**Supplementary Detailed Submission
New High School in Bungendore (SSD-14394209)
Objection to Proposal**

Submission and Comments from Council on Bungendore High School - SSD-14394209

Council's Ref: PR.2021.1036
DPIE Ref: SSD-14394209
Council Contact: M J Thompson
Council@qprc.nsw.gov.au

Proposed Traffic Infrastructure and Parking – 10 Majara Street, Bungendore

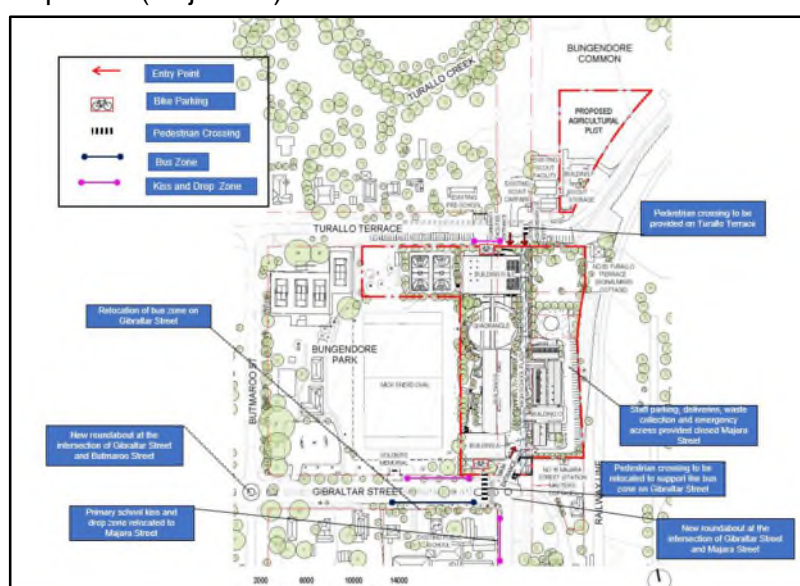
Council considers that the number of spaces on Turallo Terrace needs to be increased. While the number of pick-up/drop-off spaces have been based on 18% of student population being dropped off, this calculation will not cater for inclement weather days or winter weather where families will choose to drop off on the commute out of Bungendore.

One of the goals of the School Transport Plan is to decongest the road networks around the school and the roads most vulnerable to congestion are Gibraltar Street and Majara Street. Enhancing the Turallo Terrace pick-up/drop-off capacity will assist in decongesting the roads in the school zone most at risk of congestion.

That the drop off/pickup zone on Turallo Terrace be extended or relocated to accommodate a total of 6 vehicle spaces. (Objection)

Proposed Locations for New Pedestrian Paths (shown blue)

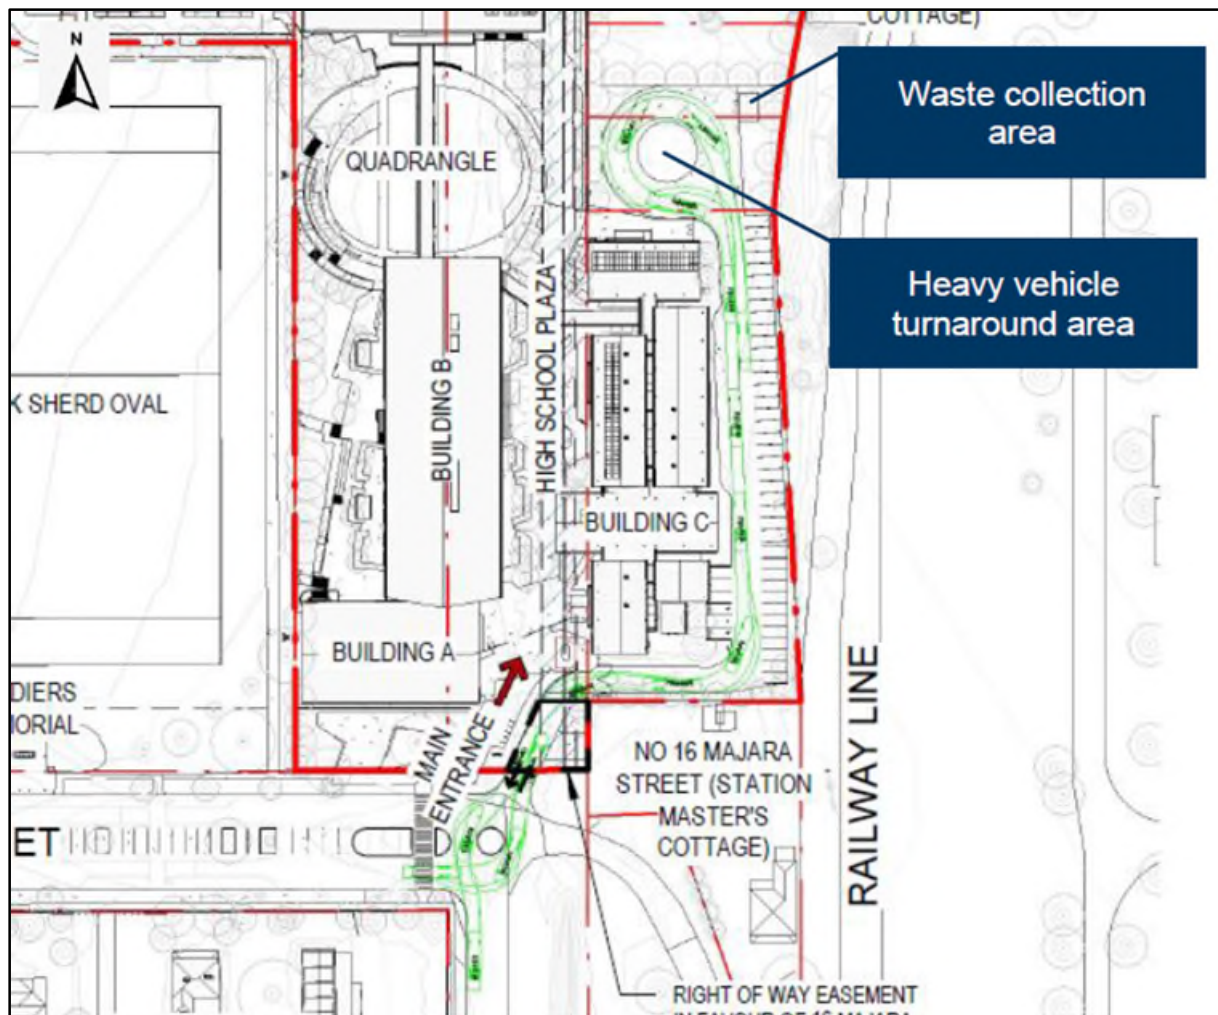
The relocation of the pedestrian path through the western portion of Bungendore Park and the formalisation of the crossing point at the eastern end of Turallo Terrace warrants a review of the paths servicing the school.

In particular paths coming from the north of the town should be extended to direct students to the safest crossing points. The sketch below shows locations where paths should be augmented shown in blue.

- That TfNSW's management of the School Crossing Supervisor Program be noted in the School Transport Plan. (Condition)
- That the requirement to provide a mandatory school crossing supervisor to support the large amount of unaccompanied school children using the crossing be included in the School Transport Plan. (Condition)
- That the school crossing supervisor be included as a member of the internal working group proposed in the Preliminary School Transport Plan. (Condition)
- That in order to reduce travel speeds consideration be given to making the proposed pedestrian crossing on Turallo Terrace a wombat crossing. (Objection)
- That the applicant be required to install new pathways as indicated in the above sketch. (Condition)
